**Land West of Cambridge Road, Stretham,  
Cambridgeshire**

**East Cambridgeshire District Council Planning  
Application Ref: 23/01338/OUM**

**Third-Party Review on Behalf of ECDC – Highways and Transport**

Project Ref: 332611436 | Rev: AA | Date: May 2024

Figure 3.3 – Site Access – Proposed T-Junction

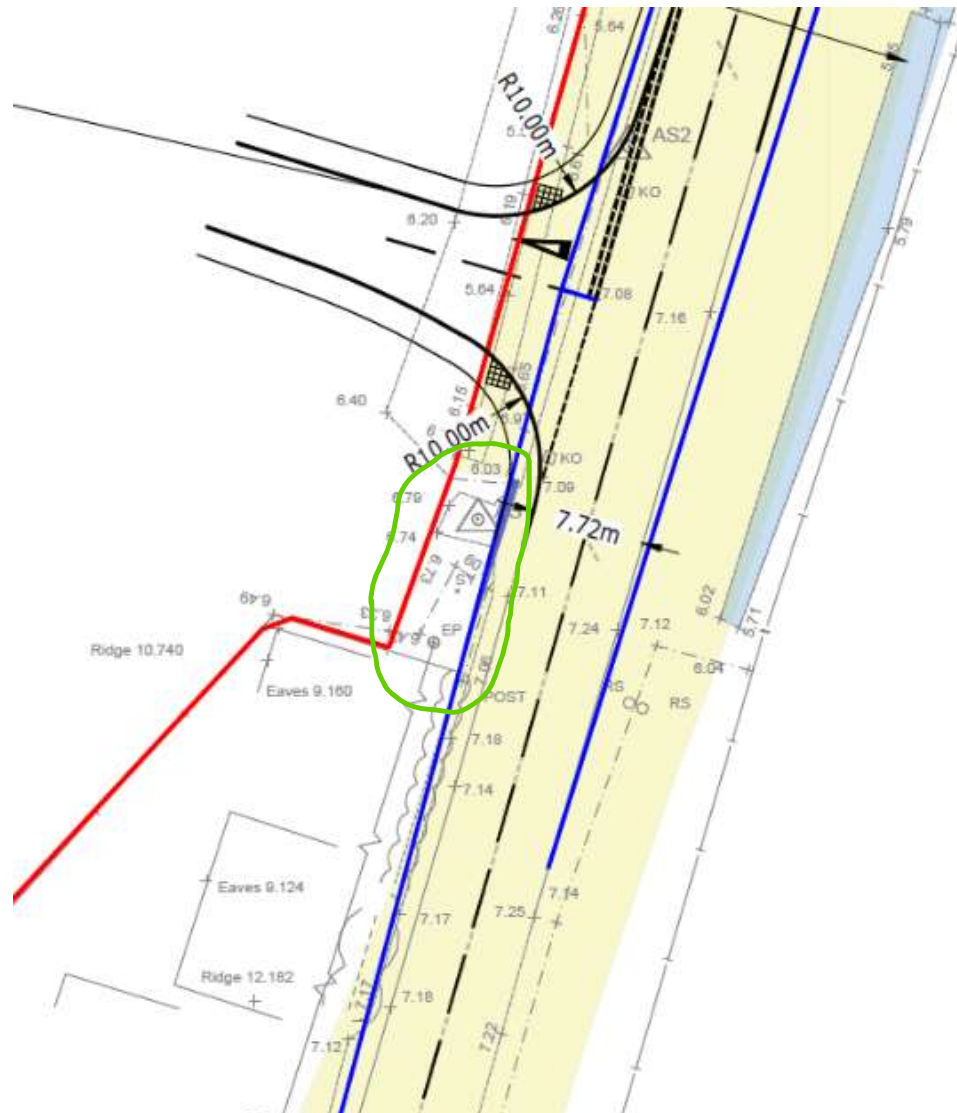
- 3.2.7 Stantec questions whether the 120m visibility splay can be achieved to the right of the proposed site access. The splay is obstructed by further existing vegetation intruding into the highway - as shown in **Figure 3.2** - as well as third-party land. The photo in Figure 3.2 has also been taken 2.4m back from the main carriageway kerbline to mimic the position of a driver waiting to turn.

3.2.8 Whilst Stantec accepts vegetation within the highway may be removed to increase visibility, the site access drawing (2006310-004 Rev B – Proposed Site Access Arrangements – Priority 'T' Junction) does not provide sufficient detail to confirm that the right visibility splay can be provided without potentially needing third-party land, as well as the construction of the footway kerb line (adopted public highway been shown as shaded yellow). The area of land in question is circled green below in **Figure 3.3**, and does not appear to be within public highway or the development red line boundary.

3.2.9 Stantec recommends the Applicant is required to provide further detail of the highway boundary for review to determine whether an appropriate visibility can be achieved without third party land.

- i) The applicant reviews the site access design to ensure the construction of the access and visibility splay to the right can be achieved without the need for third-party land.

Figure 3.4 – Google Maps Typical Traffic Conditions

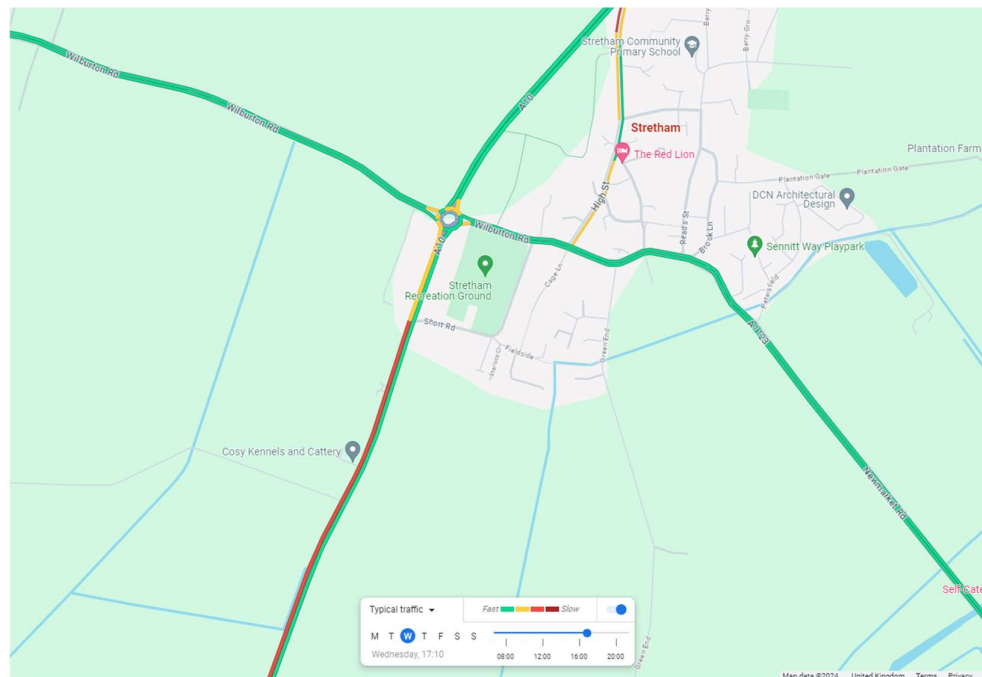
- 3.3.10 The CCC Highways Officer response referred to the A10 / A1123 roundabout peak period congestion leading to queueing traffic on the A10 extending to the proposed site access which could prevent vehicles from exiting / entering the site.
- 3.3.11 The Google Maps typical PM Peak traffic conditions shown in Figure 3.4 shows this.

- 3.3.12 As conditions at the A10 / A1123 Roundabout were not assessed as part of this Transport Assessment, Stantec is unable to comment further.
- 3.3.13 Notwithstanding,
- A development of 83 dwellings would typically generate circa. 50 two-way vehicle trips in the PM peak;
  - The Transport Assessment identified that 59% would assign northwards – this equates to 1 additional trip every 2 minutes; and
  - Whilst a development of this scale would impact conditions by a marginal amount, it is not reasonable for the developer to be expected to resolve these capacity issues.
- 3.3.14 As queues of these levels could affect the ability for vehicles to exit and enter the Proposed Development at peak times, Stantec recommends that 'KEEP CLEAR' road markings are provided across the site access frontage during the detailed design stage, to maintain access in / out of the site at peak times.

- ii) The existing street lighting on the A10 is extended past the proposed site access at the detailed design stage.
- iii) That 'KEEP CLEAR' road markings are provided across the site access at the detailed design stage to maintain access in/out of the site at peak times.
